UNITED STATES PATENT AND TRADEMARK OFFICE

APPLICATION NO.	FILING DATE	FIRST NAMED INVENTOR	ATTORNEY DOCKET NO.	CONFIRMATION NO.
10/017,483	12/14/2001	David S. Wardrop	130109.431	5180
500	7590	11/24/2003		
SEED INTELLECTUAL PROPERTY LAW GROUP PLLC 701 FIFTH AVE SUITE 6300 SEATTLE, WA 98104-7092				EXAMINER ALEJANDRO, RAYMOND
				ART UNIT 1745 PAPER NUMBER DATE MAILED: 11/24/2003

Office Action Summary	Application No.	Applicant(s)	
	10/017,483	WARDROP ET AL.	
	Examiner Raymond Alejandro	Art Unit 1745

DETAILED ACTION

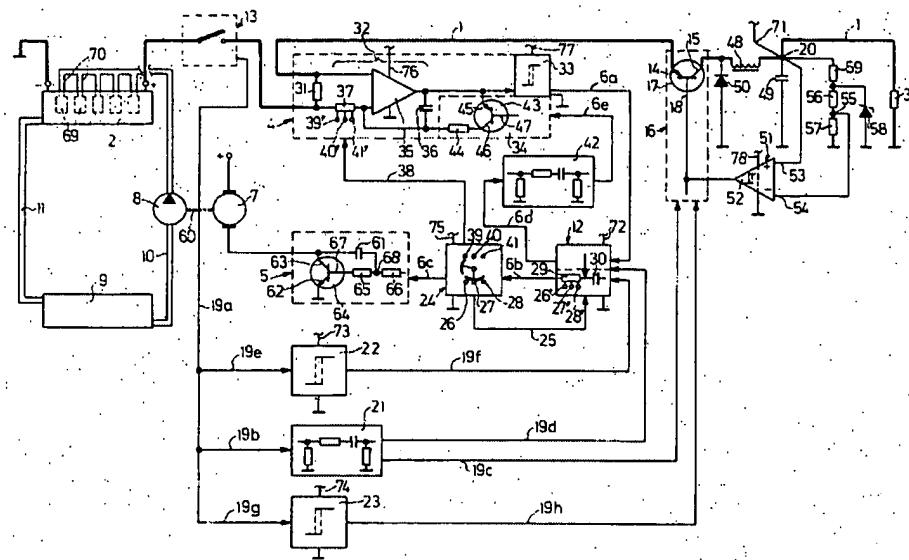
On the matter of claims 3-4:

Figure 1 below gives a picture of a schematic diagram of a regulator system according to Keller et al's invention and shows the load is located upstream downstream from the fuel cell in an air flow communication therewith and proximate to the fuel cell.
